LR-N21-0065
LAR S21-04
LAR H21-06

Salem Generating Station Units 1 and 2
Renewed Facility Operating License Nos. DPR-70 and DPR-75
NRC Docket Nos. 50-272 and 50-311

Hope Creek Generating Station
Renewed Facility Operating License No. NPF-57
NRC Docket No. 50-354

Subject: **License Amendment Request – Revision of Salem and Hope Creek
Generating Station Technical Specification (TS) to Delete Definitions found
in 10 CFR Part 20 and Delete Figures of the Site and Surrounding Areas
from TS**

5.1.3 UNRESTRICTED AREAS within the SITE BOUNDARY that are accessible to MEMBERS OF THE PUBLIC, shall be as shown in Figure 5.1-3.

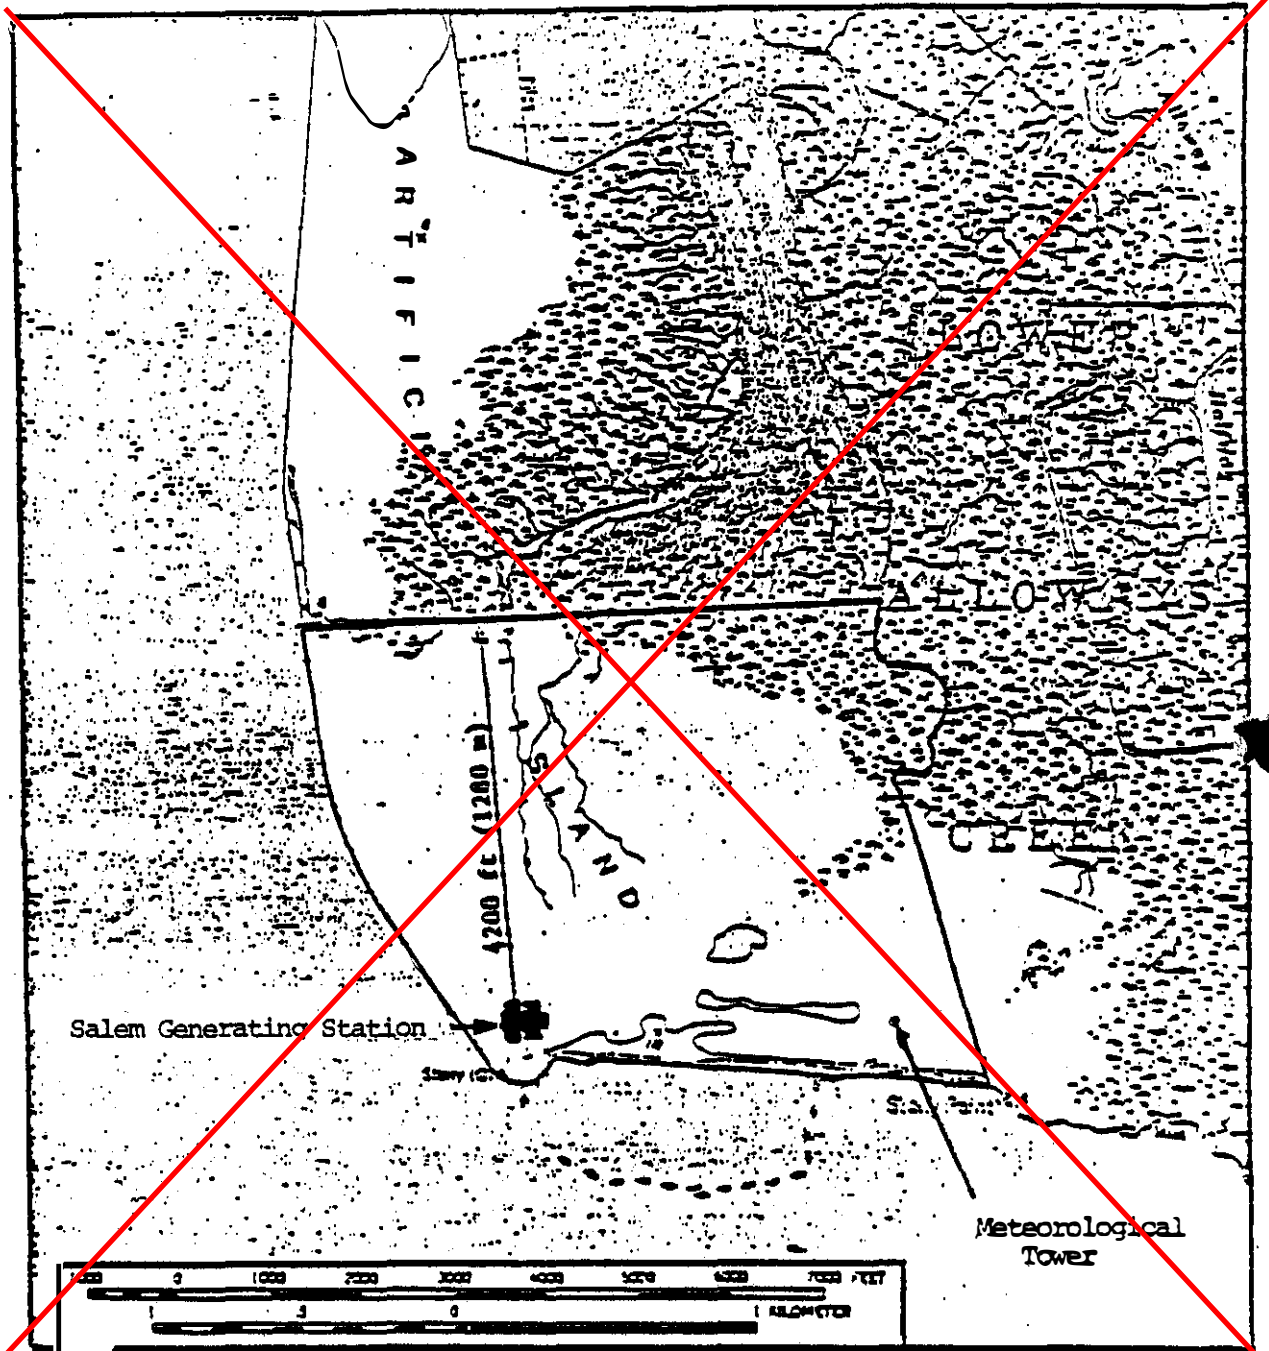
- Figure 5.1-1 – Exclusion Area – See TS Page 5-2 of Attachments 1 and 2
- Figure 5.1-2 – Low Population Zone – See TS Page 5-3 of Attachments 1 and 2
- Figure 5.1-3 – Area Plot Plan of Site – See TS page 5-3a of Attachments 1 and 2

~~EXCLUSION AREA~~
~~FIGURE 5.1-1~~

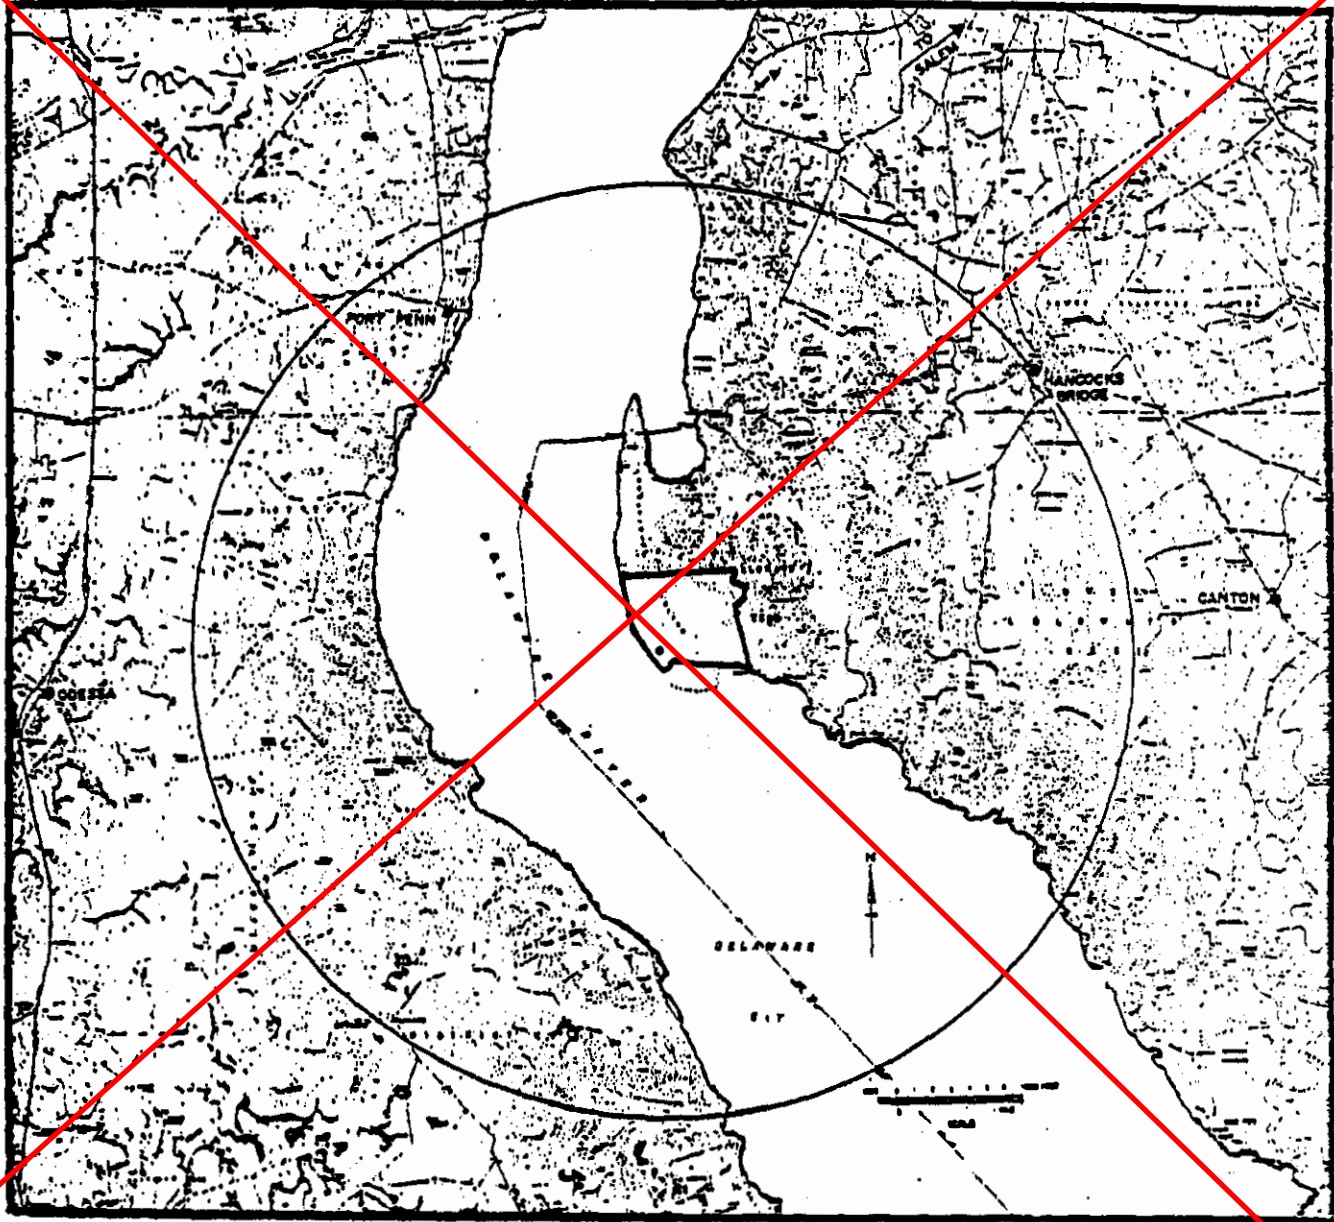
1.29 The SITE BOUNDARY shall be that line beyond which the land is not owned, leased, or otherwise controlled by the licensee, as shown in Figure 5.1-3, and which defines the exclusion area as shown in Figure 5.1-1

FIGURE 5.1.1-1

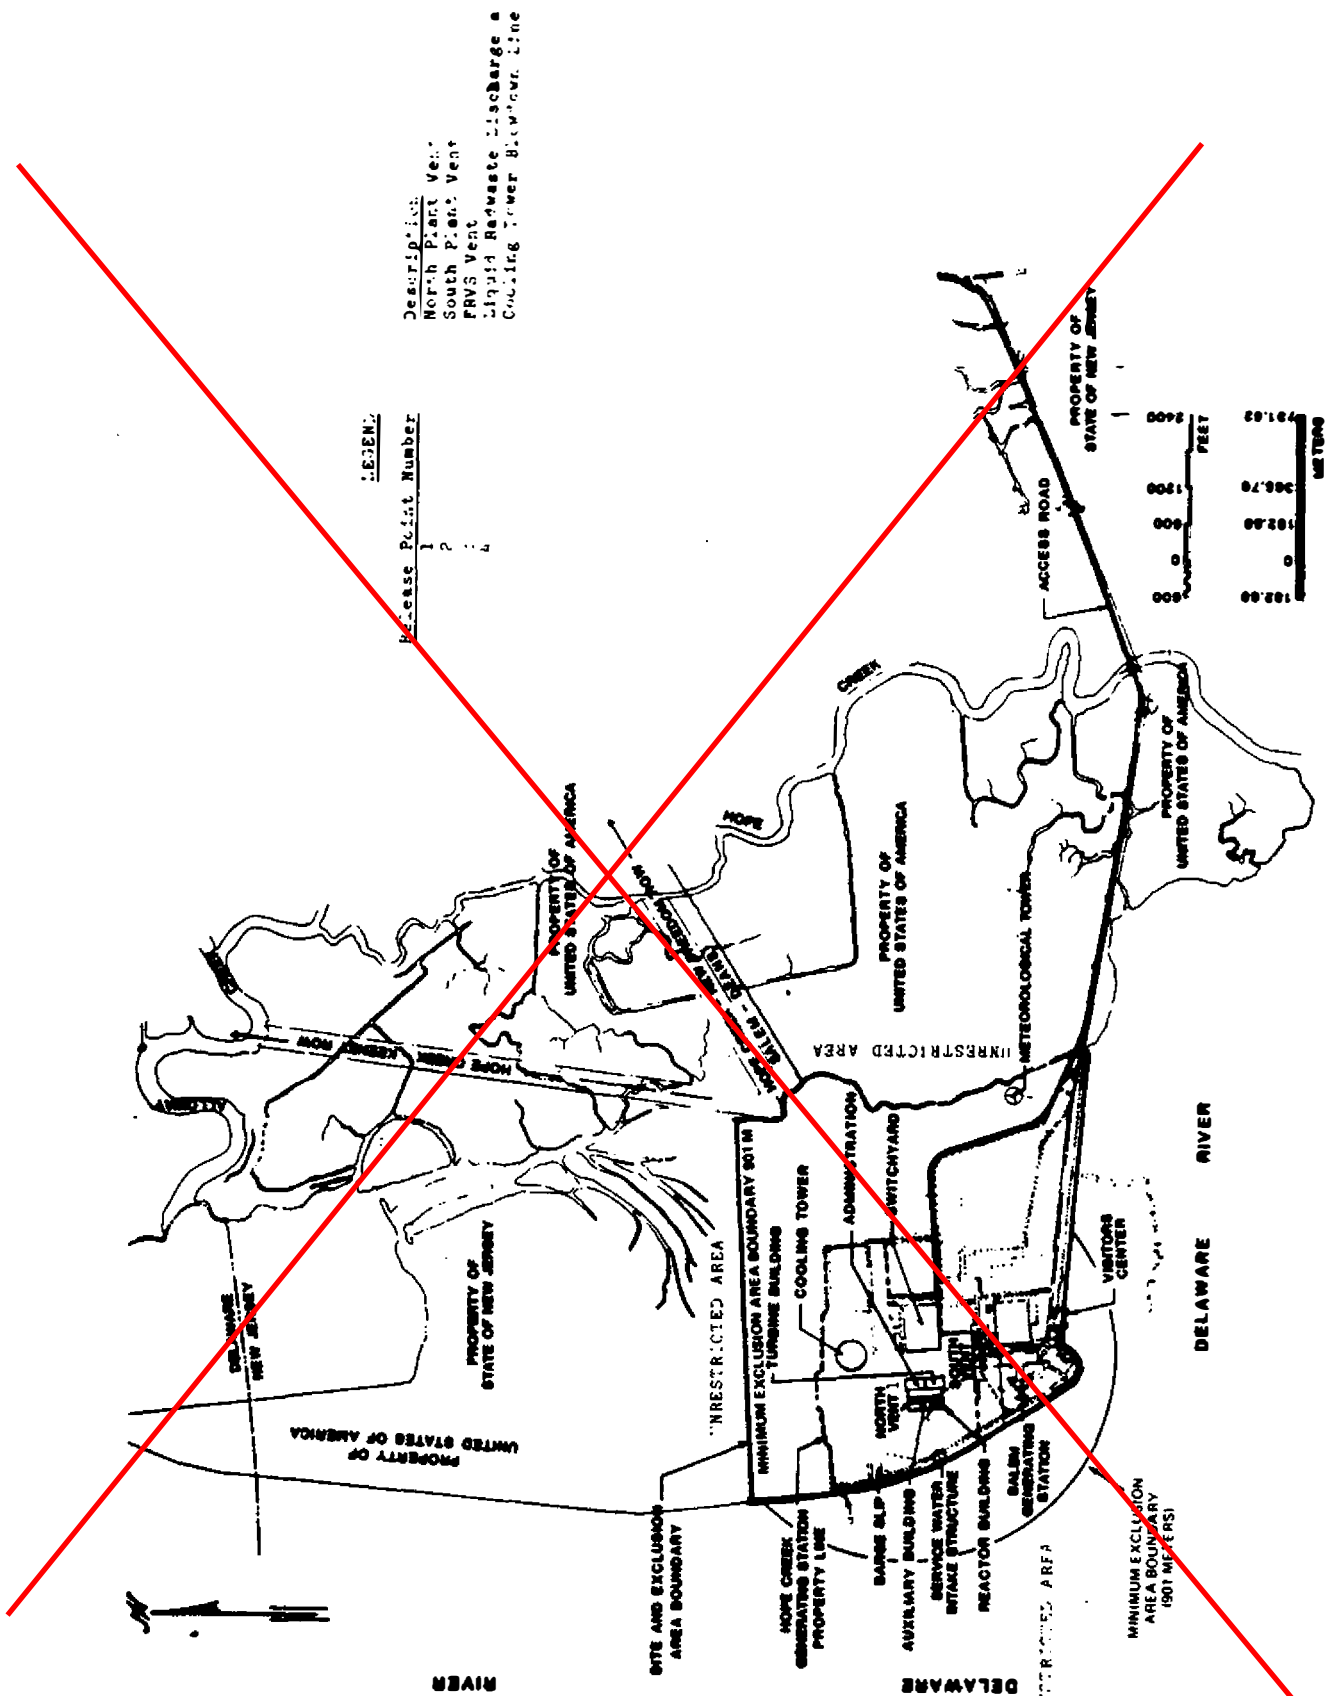
- Figure 5.1.1-1 – Exclusion Area and Unrestricted Areas and Site Boundary for Radioactive Gaseous and Liquid Effluents – See TS Page 5-2 of Attachment 3
- Figure 5.1.2-1 – Low Population Zone – See TS Page 5-3 of Attachment 3

~~5.1.1 The exclusion area shall be as shown in Figure 5.1.1-1. Information regarding radioactive gaseous and liquid effluents which will allow identification of structures and release points as well as definition of UNRESTRICTED AREAS within the SITE BOUNDARY that are accessible to MEMBERS OF THE PUBLIC, shall be as shown in Figure 5.1.1-1.~~

5.1 SITE LOCATION

Hope Creek Generating Station is located in Salem County, New Jersey along the eastern shore of the Delaware River approximately 8 miles southwest of Salem, New Jersey and 18 miles south of Wilmington, Delaware.

FIGURE 5.1.2-1

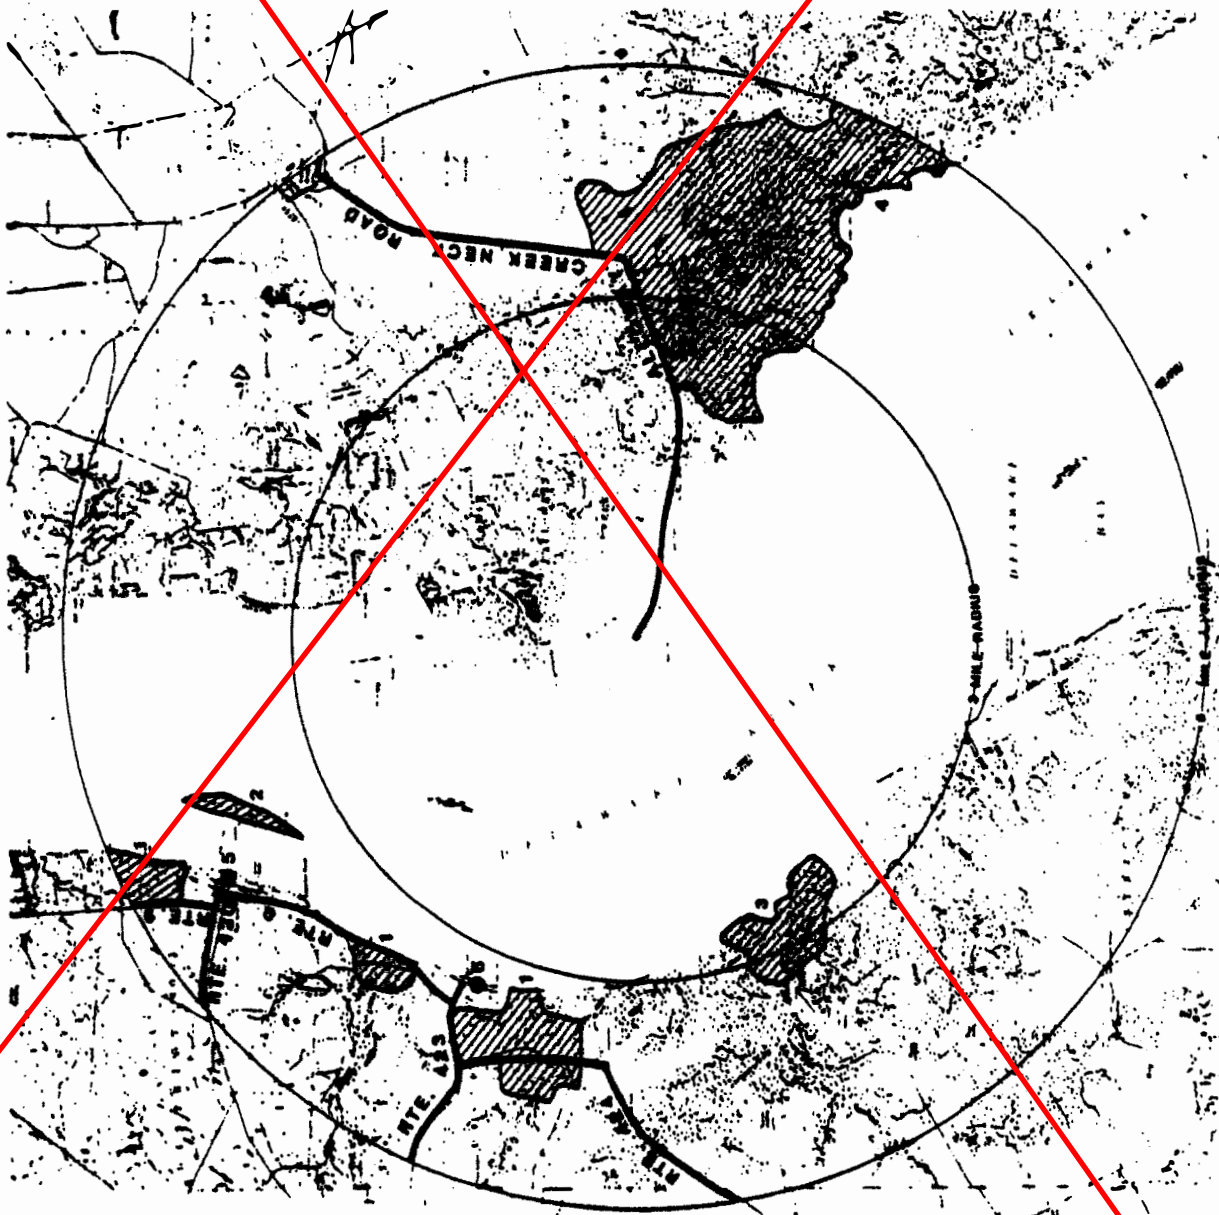
~~5.1.2 The low population zone shall be as shown in Figure 5.1.2-1. The circle with the five mile radius is the low population zone.~~
